Model: Sorter Stapler for Penguin		Date: 30-Jun-99	No.: MA821001
Modified Article: Philips Truss Head Screw - M4x6		Prepared by: F. Noguchi	
From: Technical Service Dept., GTS Division			
Reason for Modification:	<input type="checkbox"/> Parts catalog correction <input type="checkbox"/> To facilitate assembly <input type="checkbox"/> Part standardization	<input type="checkbox"/> Vendor change <input type="checkbox"/> To improve reliability <input checked="" type="checkbox"/> Other	<input type="checkbox"/> To meet standards ()

Model: Sorter Stapler for Penguin		Date: 15-Jul-99	No.: MA821002
Modified Article: Punch Unit & Punch Drive Bracket (2 Holes only)		Prepared by: H.K.	
From: Technical Service Dept., GTS Division			
Reason for Modification:	<input type="checkbox"/> Parts catalog correction <input type="checkbox"/> To facilitate assembly <input type="checkbox"/> Part standardization	<input type="checkbox"/> Vendor change <input checked="" type="checkbox"/> To improve reliability <input type="checkbox"/> Other	<input type="checkbox"/> To meet standards ()

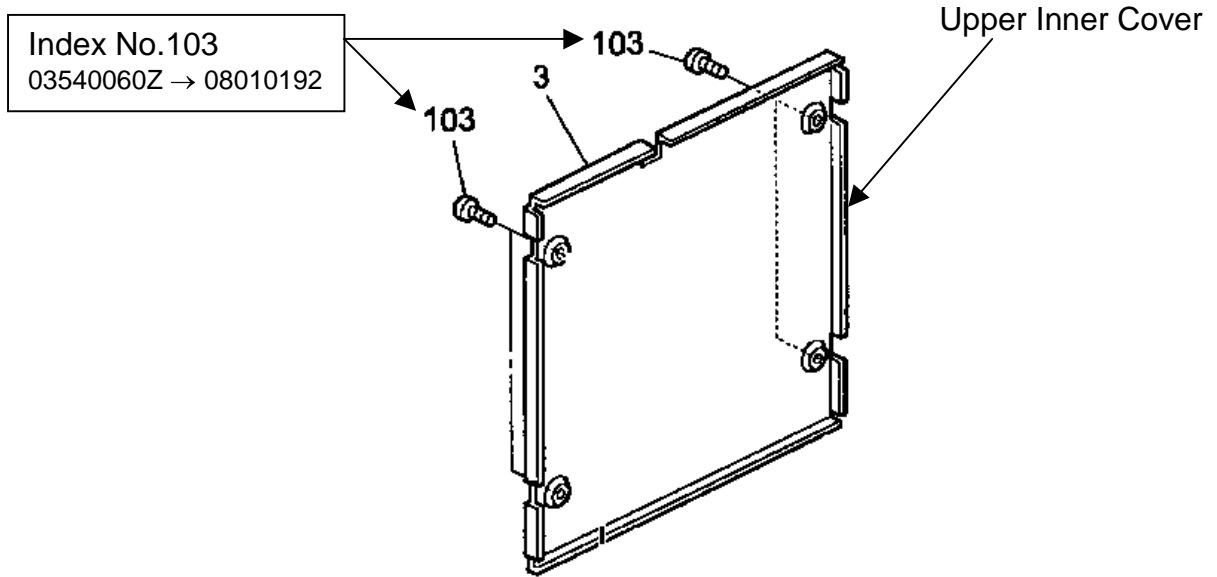
When clearing a paper misfeed, it is not uncommon for the cover screws to slightly scratch the back of the hand. To prevent this, the shape of the tip of the screw has been rounded off.

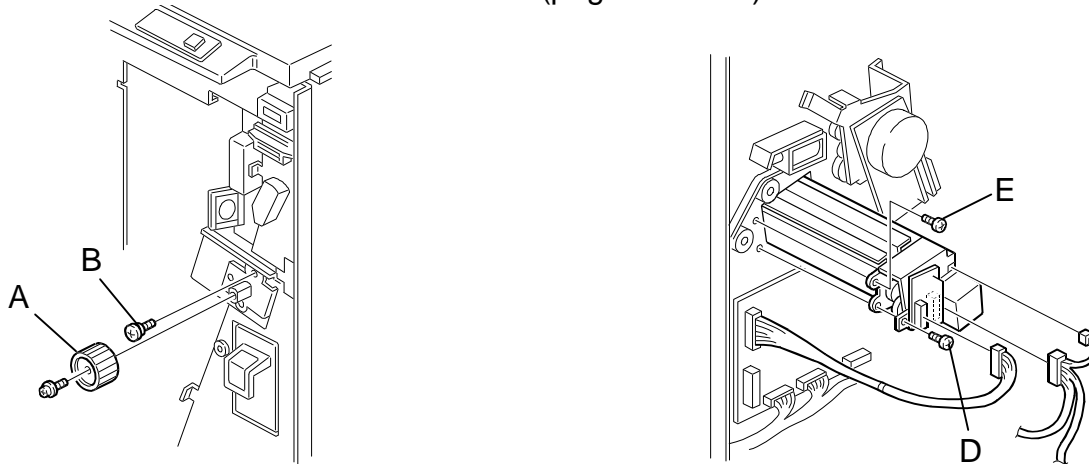
To prevent the punch unit from becoming distorted, the lower screw for securing the punch unit to the rear side is left un-tightened. If this were not done, the edges of the punched holes in thick paper (such as 128 g/m²) will not be clean. The note about the lower screw is mentioned in the service manual (page A821-52) as follows:

NOTE: To prevent the punch unit from being distorted, re-assemble the parts as follows:

- 1) Push in the punch unit and install the shoulder screw [B].
- 2) Install the knob [A] (1 screw).
- 3) Temporarily secure the lower screw [D] for the rear.
- 4) Secure the upper screw [E] for the rear.
- 5) Set the connectors.
- 6) Leave the lower screw [D] un-tightened.

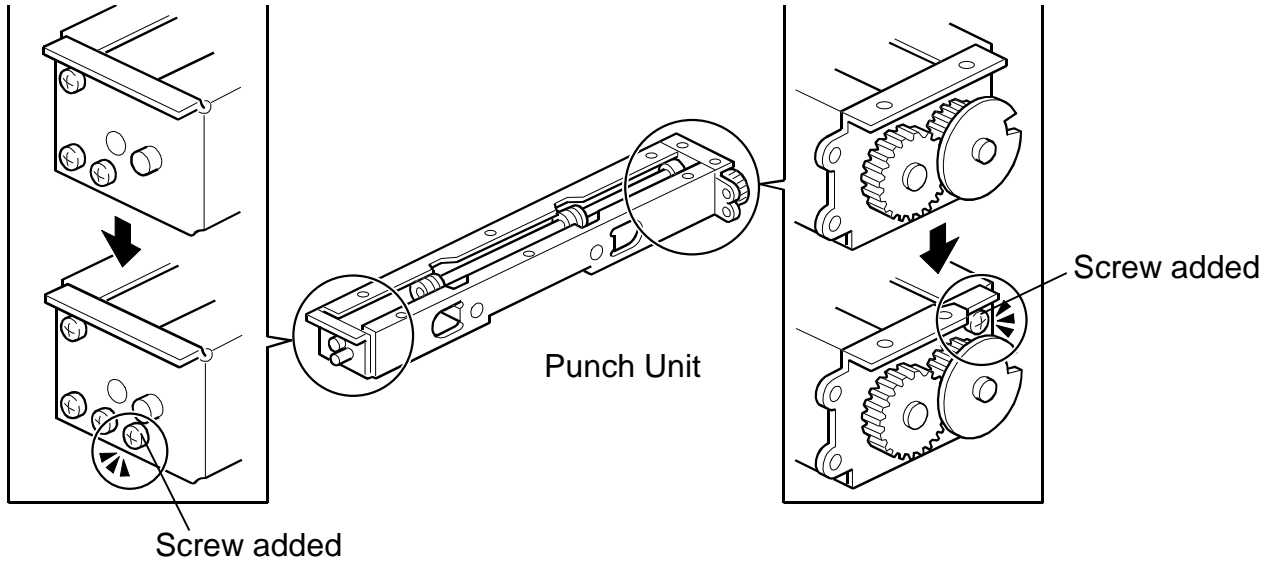
To reduce the possibility of distortion of the punch unit, two additional screws have been added to the punch unit and the configuration of the punch unit has been changed.

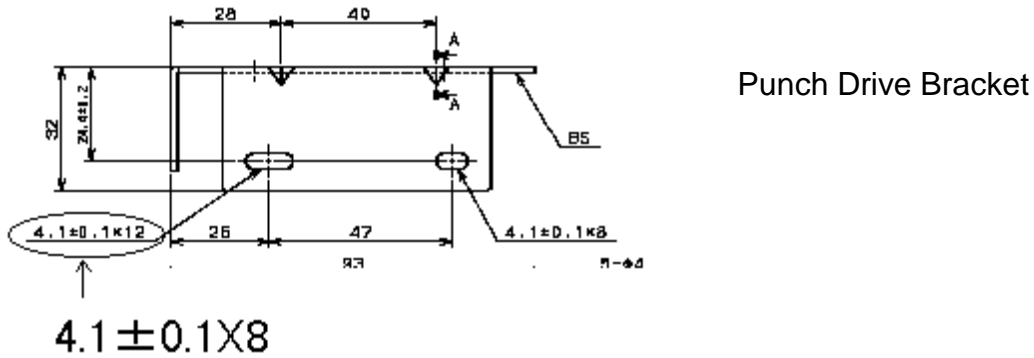
Due to the above punch unit modification, the screw position of the punch drive bracket have been changed. The length of the oval hole in the punch drive bracket has been changed from 8 mm to 12 mm.

As the new punch drive bracket can be installed in the old machine physically, the old bracket will no longer be supplied. When the new punch unit is installed in the old machine, it is necessary to replace the punch drive bracket with a new one together with the new punch unit.
